**Environmental  
Planning  
Commission**

**Agenda Number: 07  
Project Number: 1008444  
Case #s: 13EPC-40162  
February 13, 2014**

**Staff Report**

The Planning Department requests an Environmental Planning Commission (EPC) recommendation to City Council to approve text amendments to the Volcano Cliffs Sector Development Plan (SDP).

Exhibit 5, Volcano Mesa Road Network

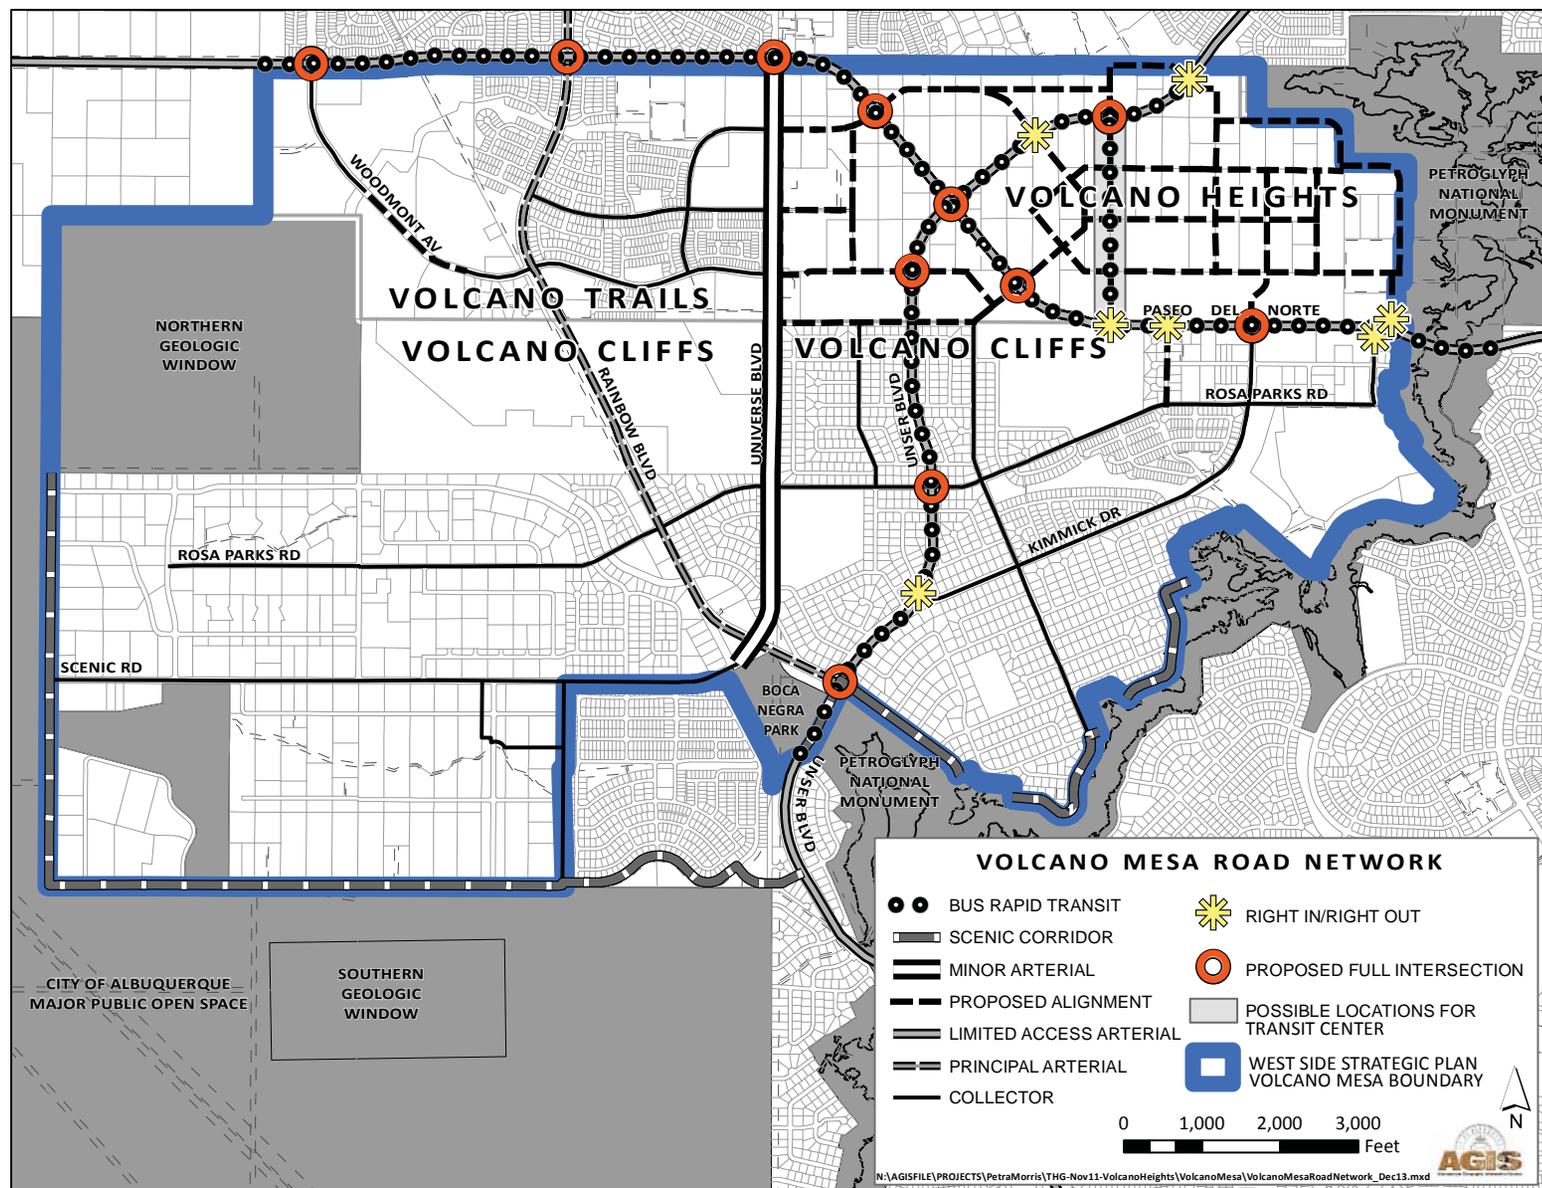
- 3) On page 29: Update road network map with Primary Streets and intersections as adopted in the Volcano Heights SDP.
  - ***Following the original intent of the Volcano plans, this change provides a consistent road network for Volcano Mesa, incorporating streets in the Volcano Heights SDP as well as updates made to access points on the limited-access Paseo del Norte and Unser Boulevard through the Metropolitan Planning Organization.***

1. On page 29, Exhibit 5, the Volcano Mesa roadway network map, change the symbol at the southern terminus of Transit Boulevard to indicate a full-access, signalized intersection. [1]

2. On page 29, Exhibit 5, the Volcano Mesa roadway network map, change the designation of Woodmont Avenue to a minor arterial. [2]
3. On page 29, Exhibit 5, the Volcano mesa roadway network map, edit the legend to delete “proposed” where it appears. [3]

Exhibit 6, Volcano Cliffs Sample Cross-Section Locations

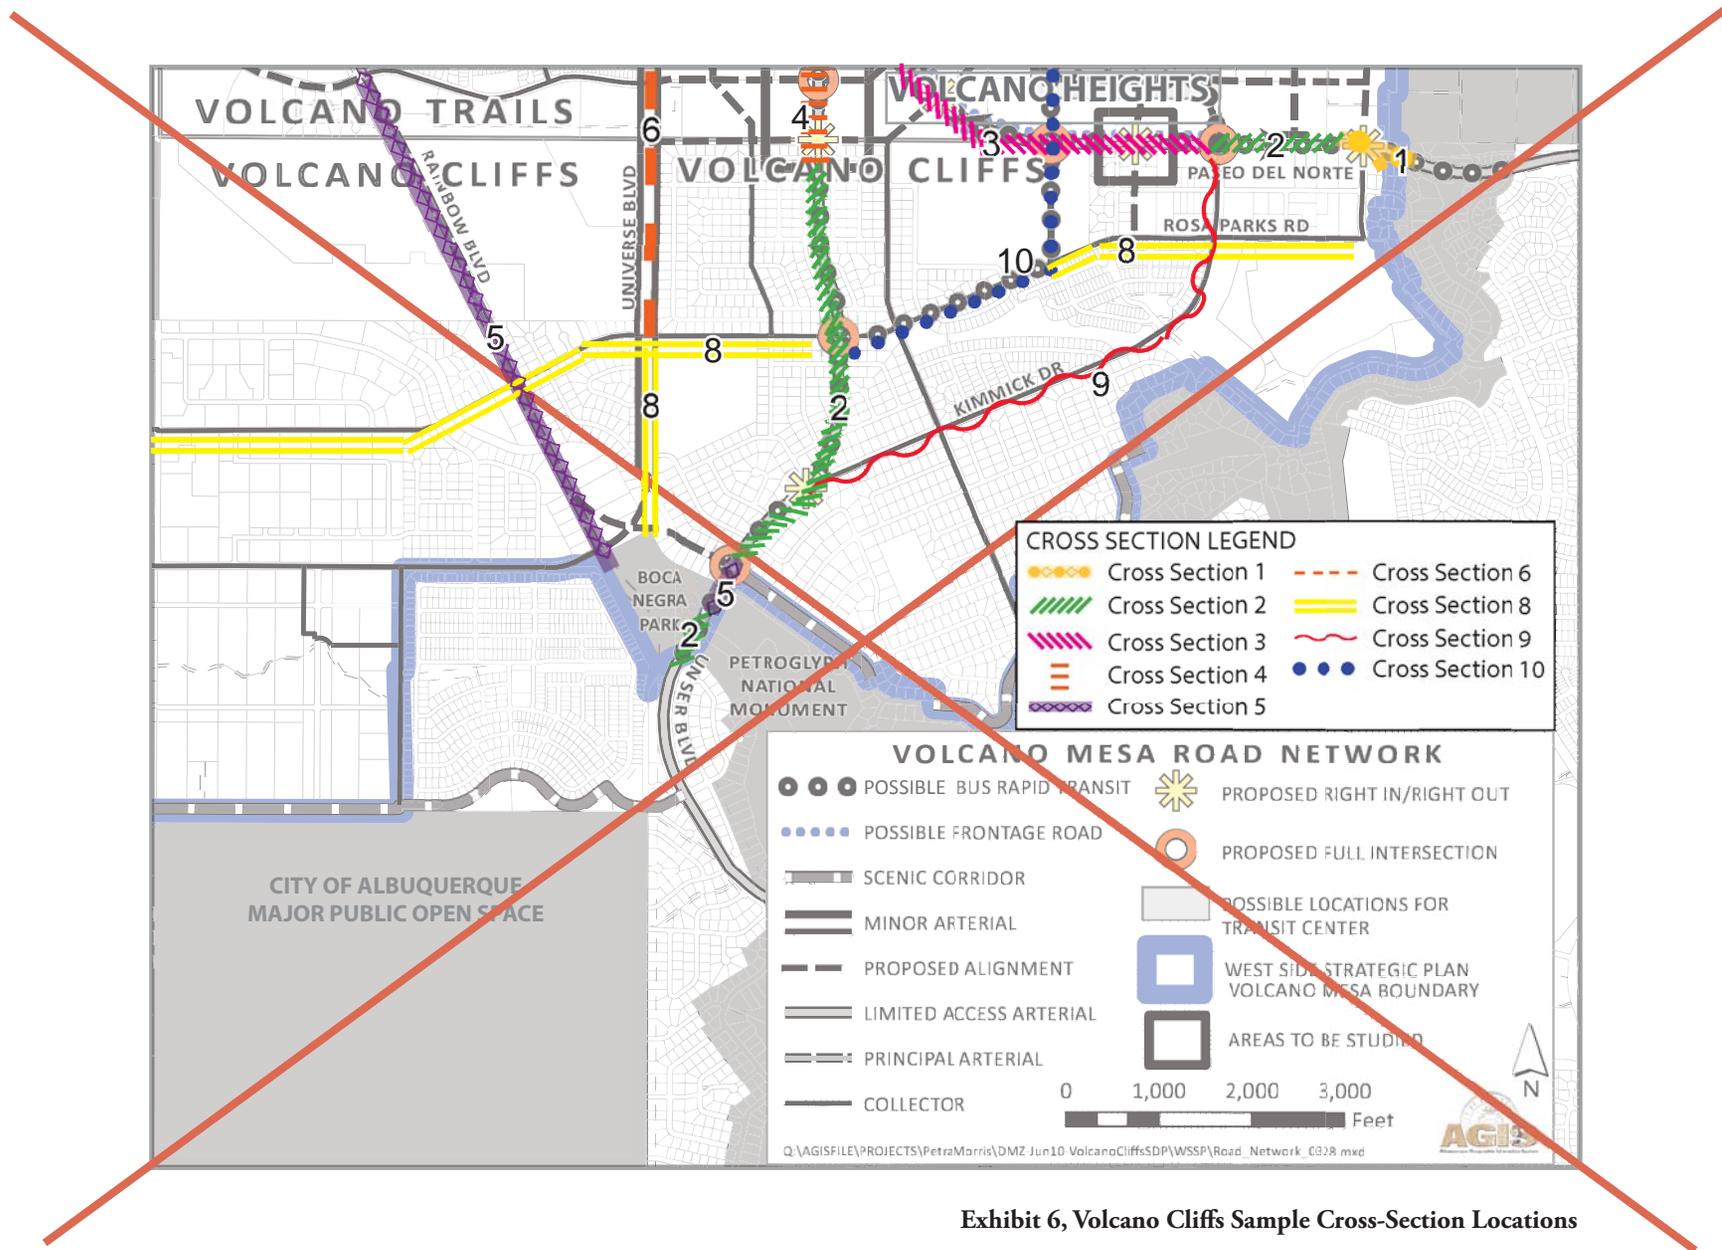
- 5) On page 36: Update Exhibit 6 to reflect Primary Streets and cross sections as adopted in the Volcano Heights SDP.
  - ***As originally intended at the start of the process to create the three Volcano plans, this change updates the cross sections to incorporate subsequent analysis and revisions made during the Volcano Heights SDP process. The proposed***

Street Type 7.1 – Urban Boulevard A

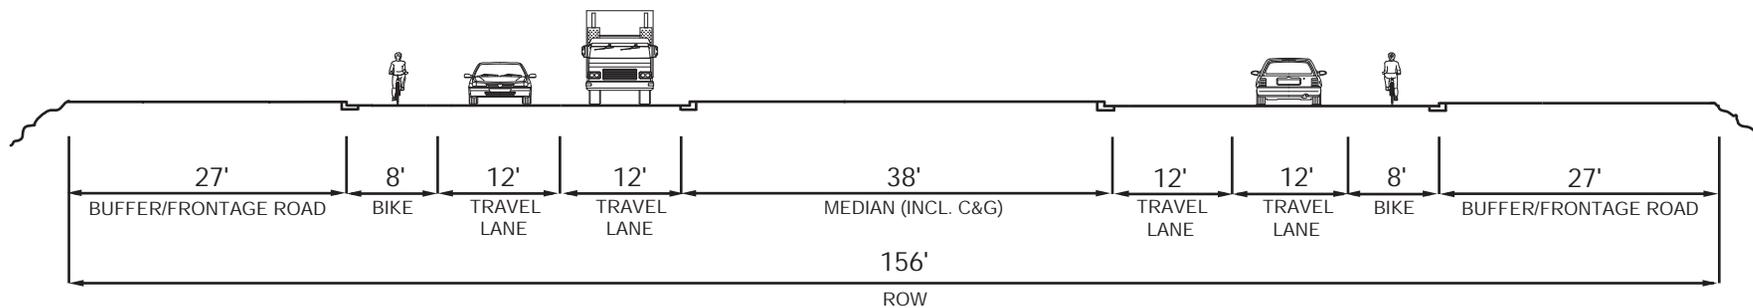
8. Pages 163 / 164 - Cross section ST7.1 does not make sense for Paseo del Norte. Specifically, why would BRT lanes on Paseo del Norte transition from being outside lanes in cross section 7.4, to median lanes in cross section 7.1, and then back to outside lanes in cross section 6?
9. Page 187 / 188 - Which side of the road is the multi-use trail on in cross section ST7.3 for Unser Blvd. and ST7.4 for Paseo del Norte? What is the purpose of the multi-use trails as they are not part of the other cross-sections for Unser Blvd. and Paseo del Norte.

Exhibit 10, PNM Electric Facilities  
[Updated to show Scenic facility]

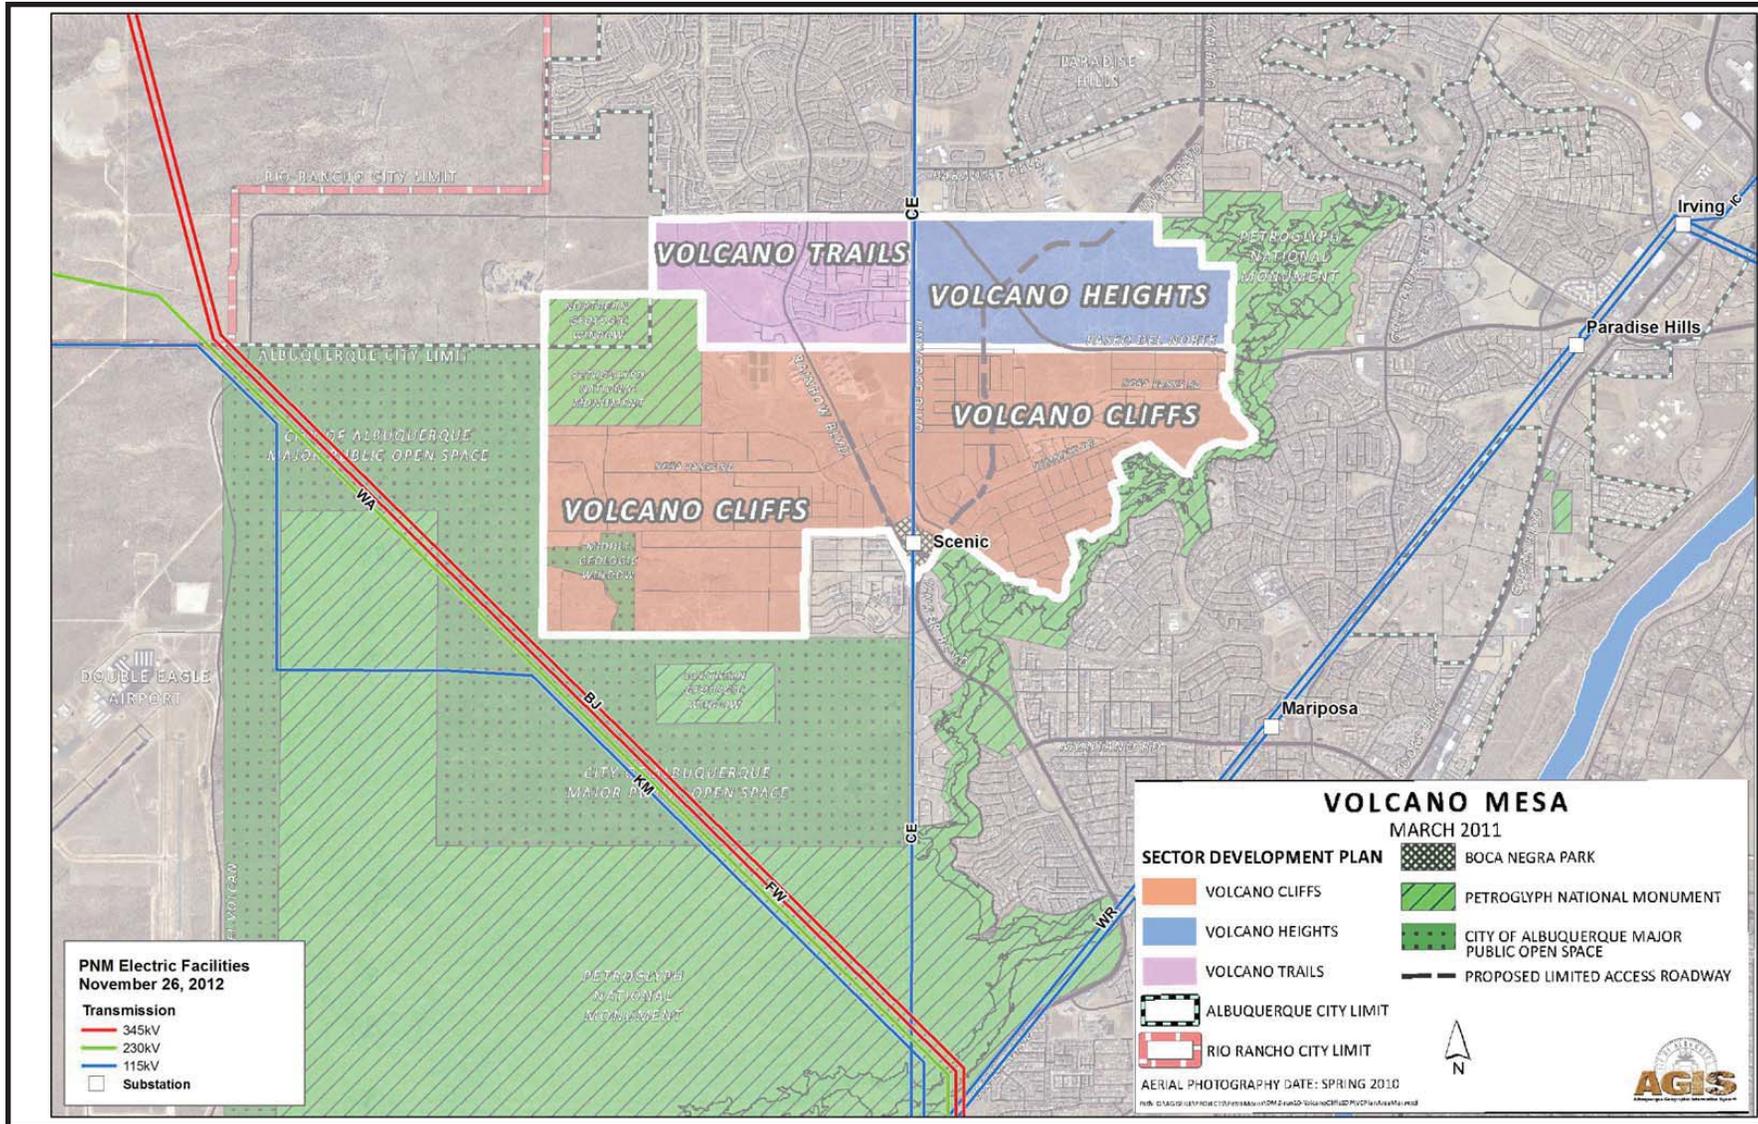
- 4) On page 70: Replace Exhibit 10 with updated graphic from PNM in VHSDP (Appendix A-39).

- 
- *The map of existing electric facilities in was updated to reflect projects completed after VCSDP's adoption in 2011.*
- 5) On pages 71-72: Replace Section 5. Residential Garages in its entirety with language, table, and graphics from Section 7.7 in VHSDP (pages 127-128).

Figure 7, Garage Type Diagrams

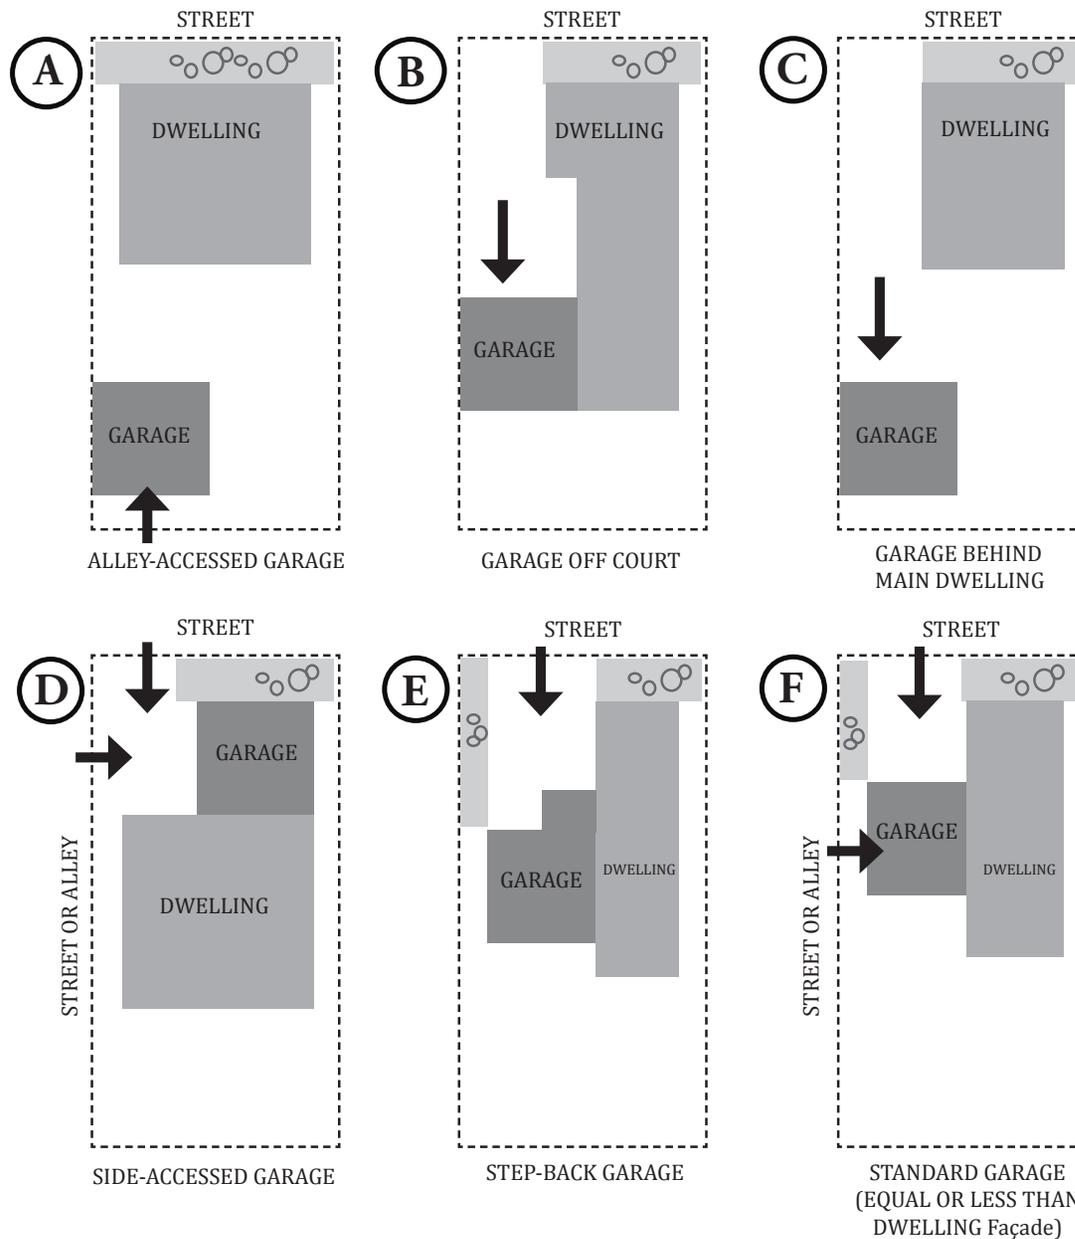
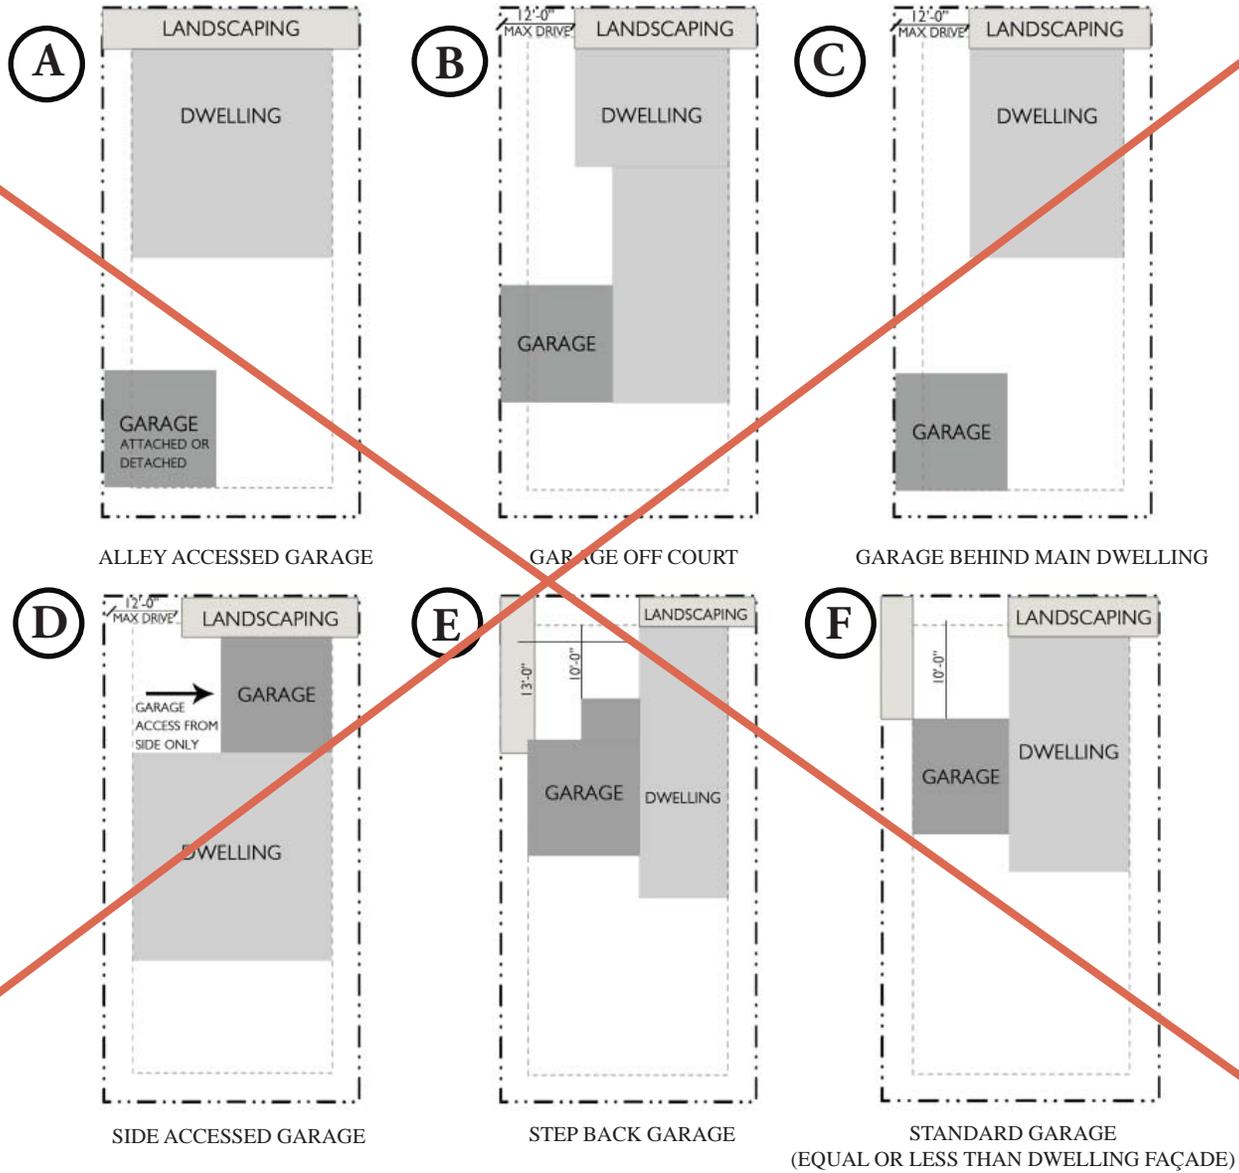
- *Residential garage text and diagrams were revised for Volcano Trails and further revised in Volcano Heights, partly in response to comments received by developers in Volcano Cliffs and Volcano Trails. The revisions are largely to clarify intent and measurements, as well as reworking graphics to be more understandable as illustrative diagrams (not to scale).*
